Site: MJ Hospitality, LLC., Self Storage, 1400 Yale Blvd NE

Re: Drainage Ordinance (14-5-2-1) Violations for Erosion and Sediment Control

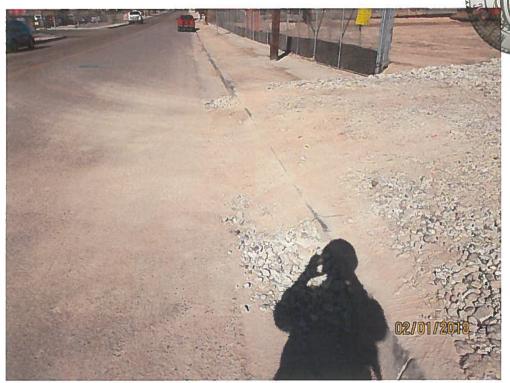
- 1. The track-out pad/stabilized construction entrance was built over the sidewalk.
- 2. Dirt and rocks were placed in the gutter pan as a ramp.
- 3. In one location, the dirt was graded too high against the silt fence which caused a breach and put sediment on the sidewalk.
- 4. In other locations along the west and north side of the site the grade is too high against the silt fence.

Track-out pad built over the sidewalk.

- 1. The track-out pad/stabilized construction entrance needs to be re-built so that: there are no rocks on the sidewalk, the rocks should be removed and the grade be cut down behind the sidewalk and between the sidewalk and gutter so that when the aggregate is placed for track-out control the top of the rocks is not higher (approximate) than the sidewalk or curb. This will help prevent rocks from getting onto the sidewalk and falling into the gutter. Filer fabric is to be placed under the aggregate. Filter fabric extends the life of the track-out pad as the aggregate will not get "pushed" into the soil.

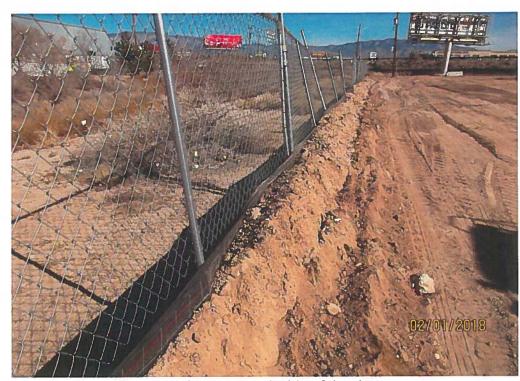
Grade too high against silt fence on west side of the site.

- 5. In other locations along the west and north side of the site the grade is too high against the silt fence and it is to be lowered adjacent to the silt fence so it is near (1/4 height or less) the bottom of the silt fence
